SERVICE BULLETIN

No. 384

<u>Subject:</u>	Inspection of Propeller Blade Shank -- reference attached Hartzell Service Bulletin No. 94A dated March 1, 1973
<u>Models and Serial Numbers Affected:</u>	Refer to attached Hartzell Service Bulletin No. 94A, <u>Effectivity</u> .
<u>Compliance Time:</u>	Refer to attached Hartzell Service Bulletin No. 94A, <u>Required Action</u> .
<u>Purpose:</u>	To provide distribution of the attached Hartzell Service Bulletin No. 94A, dated March 1, 1973 to owners and operators of affected PA-31 Navajo aircraft.

Subject: Inspection of Propeller Blade Shank

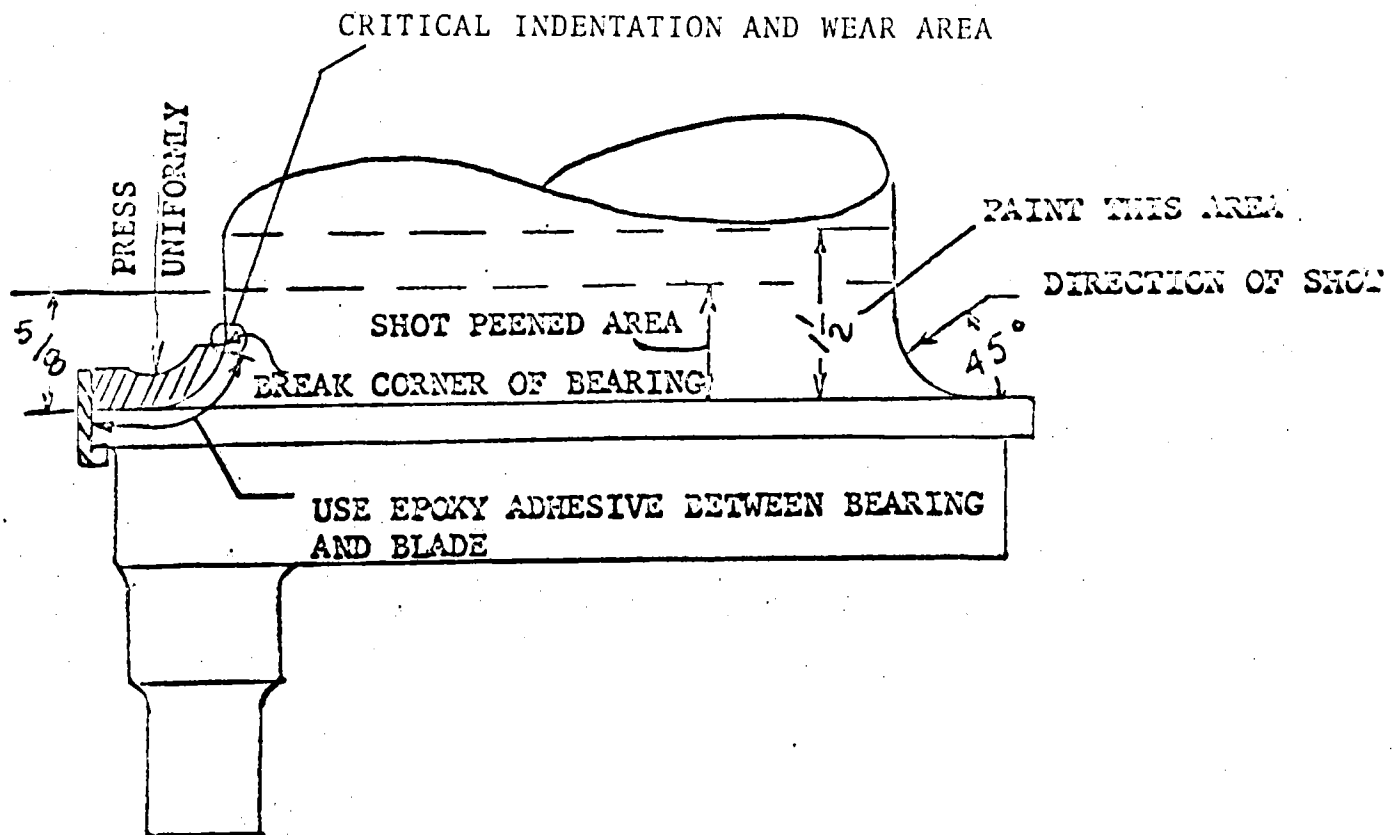
- 1) For propellers which have been in service for 1000 hours or more inspect the blade shanks within the next 100 hours, by the dye penetrant method, for cracks in the radius adjacent to the retention flange.
- 2) Regardless of previous inspection, inspect for possible indentations and wear due to the sharp edge of the bearing as shown on the sketch. Blades showing wear in this critical area must be retired from service.
- 3) For those blades not rejected, inspect for chafing, fretting, or unusual wear where the A-2202 bearing race contacts the blade retention radius. If this surface is worn or marked in any way, carefully fit the A-2202 bearing race by polishing the radius area only. It is suggested that the blade be chucked in a lathe for uniform radius polishing.

- 4) Re-shot peen the radius as shown on the sketch. Use S-390. Cover 100 percent. Test the effectiveness of the peening with the C-2 Almen gage. The arc height should be .007 minimum.

- 6) Clean the blade retention shoulder with a solvent. (The polyurethane paint need not be removed.) Clean the mating surface of the A-2202 bearing race after the sharp corner is broken (see sketch).
